Registry No. H11826

General Locality Colvos Passage and Vicinity

Sublocality Three Tree Point to Robinson Point

Descriptive Report to Accompany Hydrographic Survey H11826

Figure 2: Junction comparison with 11827 as viewed in CARIS subset editor. Lines are colored by survey.

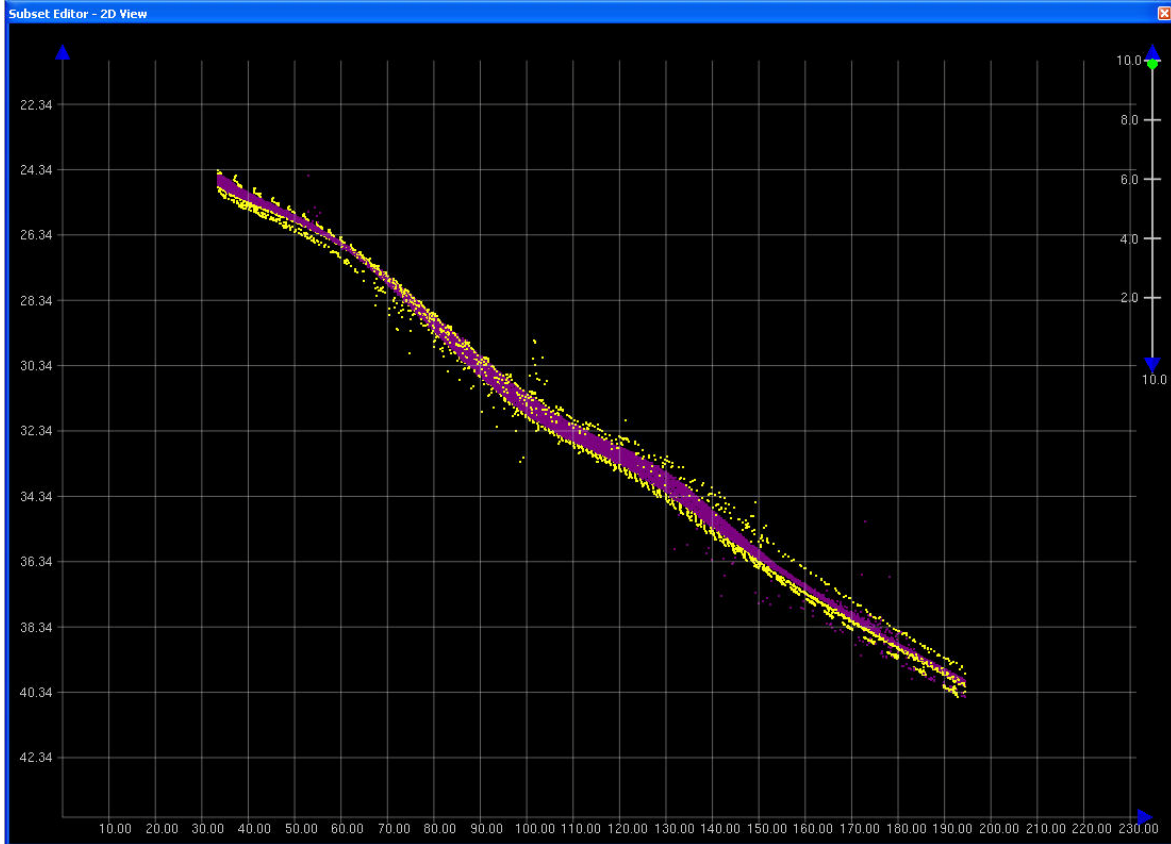
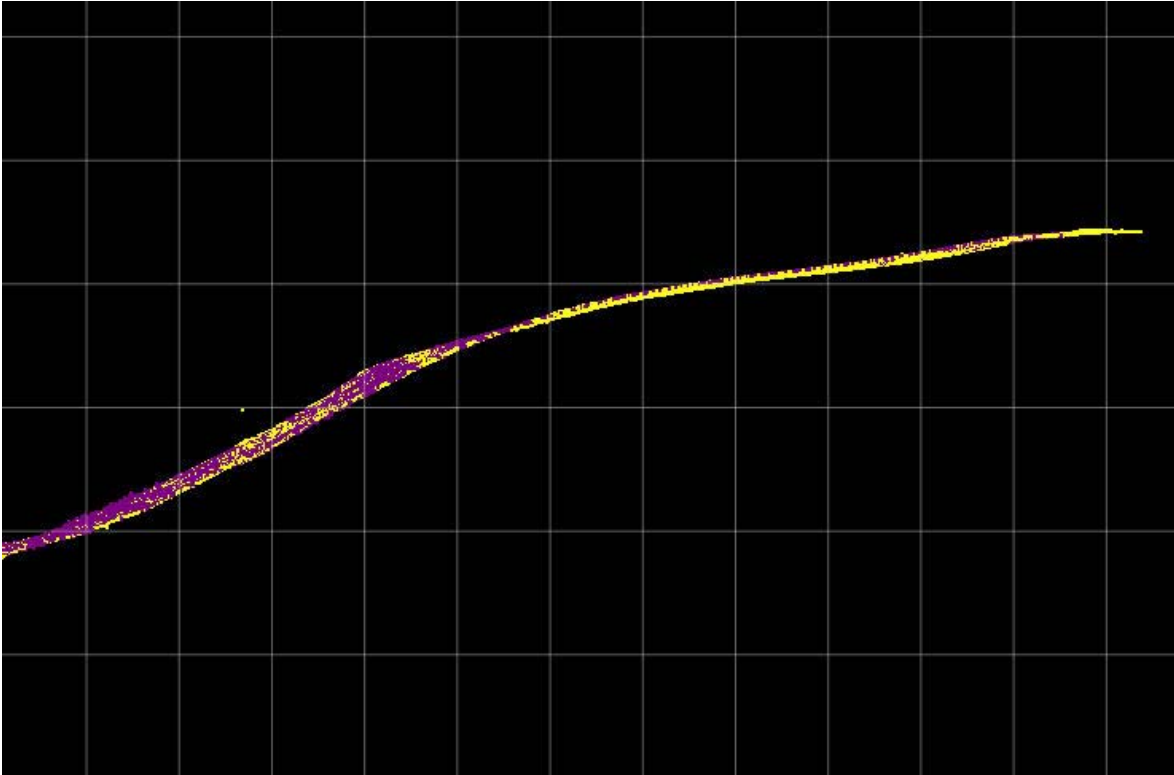
Surveys H11827 and 11646 were completed concurrently with survey H11826 during project OPR-N395-RA-08. Survey data was compared in CARIS subset mode and agreed well with no discernable differences in the common area. See Figures 2 and 3.³

³ The junction with surveys H11827 and H11646 will be discussed in their Descriptive Reports. A common junction with these surveys will be made when they are compiled.

Figure 7: Horizontal Offset of 1.65m and the effect of the offset on the 1 meter surface.

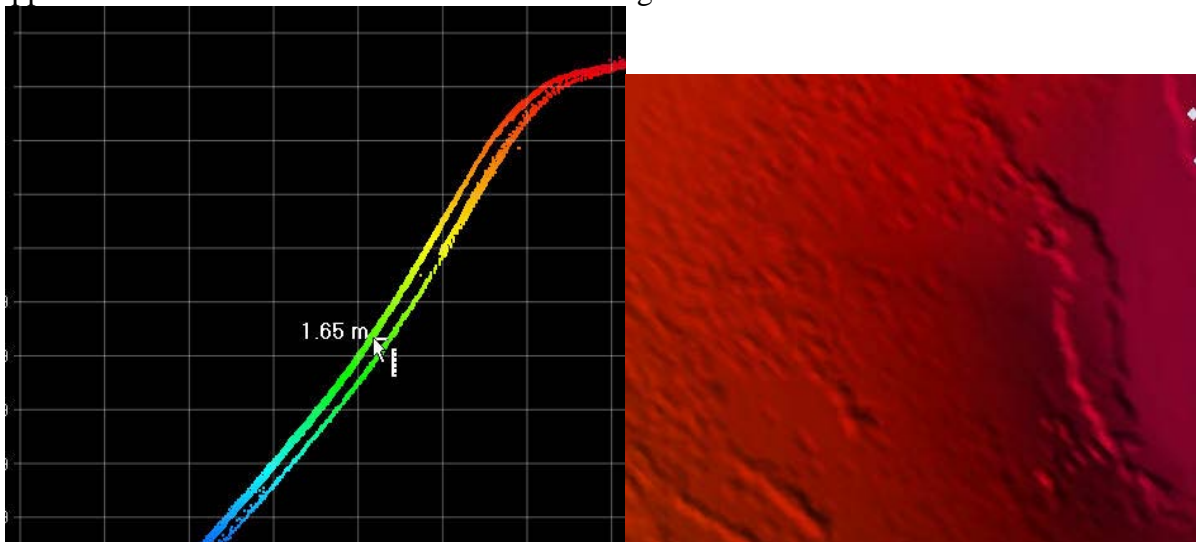
Horizontal offsets were seen in the steep slopes along the edges of East Passage, and appeared to be an artifact of horizontal positioning. The POS MV unit has a stated horizontal accuracy of 2 meters, and variations within this accuracy become apparent on a slope. Offsets observed were within the 2 meter accuracy of the POS in examined areas. The effect on the surface and appearance in subset editor are shown below in Figure 7. ⁶

⁶ Despite the horizontal offset, the data is adequate to supersede charted data.

Figure 13: Maury-Des Moines Cable Trench in 1-meter resolution bathymetry overlaid on chart 18474

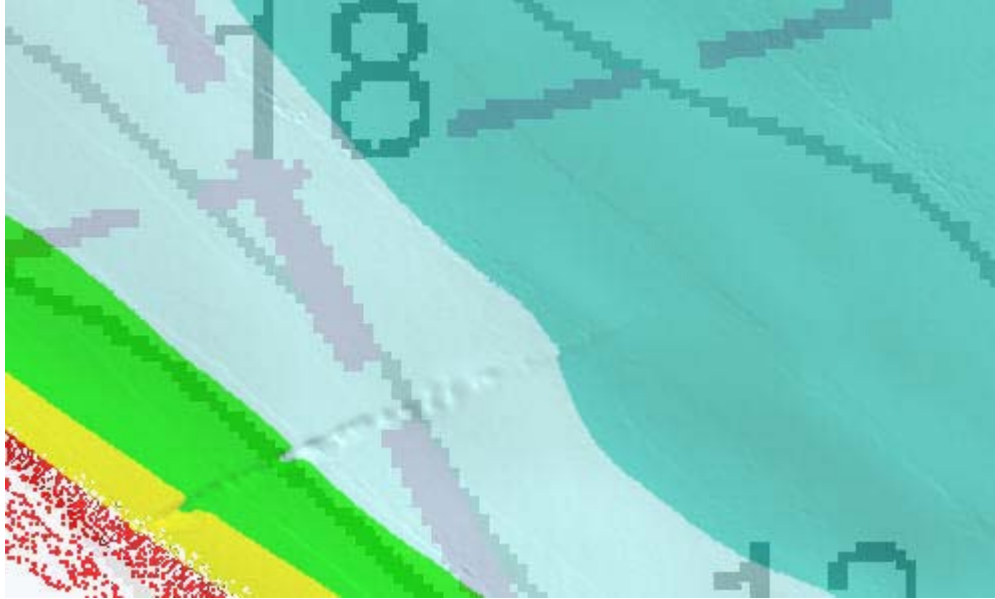
- Maury-Des Moines Cable Area: A trench was located at the western end of the cable area extending between Des Moines and Maury at the southern end of the survey area. See Figure 13. The Hydrographer recommends retaining the cable area as charted.²¹

²¹ Concur

Figure 16: Pipeline in 1-meter resolution bathymetry overlaid on Chart 18474.

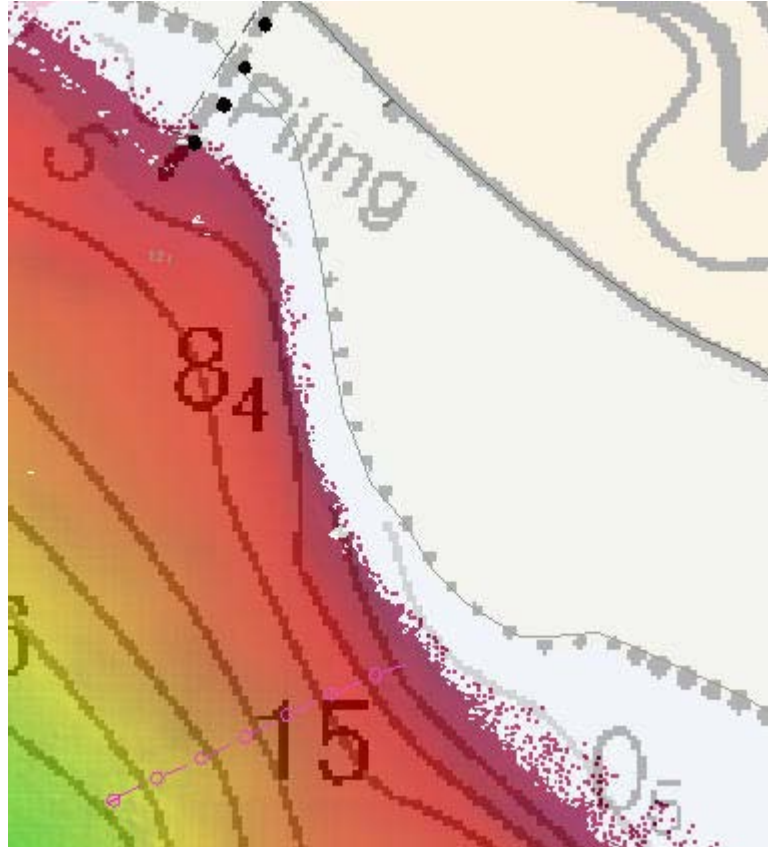
- Three Tree Point: A pipe was observed in the bathymetry and confirmed with Side Scan Editor at position 47° 26.48'N 122° 21.86'W. A digitized pipeline was added by the hydrographer in H11826_FieldVerified_Source.hob in the Notebook session (H11826.wrk) and was properly attributed as a new feature. The hydrographer recommends adding to chart.²⁵ See figures 16 and 17.

²⁵ Chart as depicted on the HCell
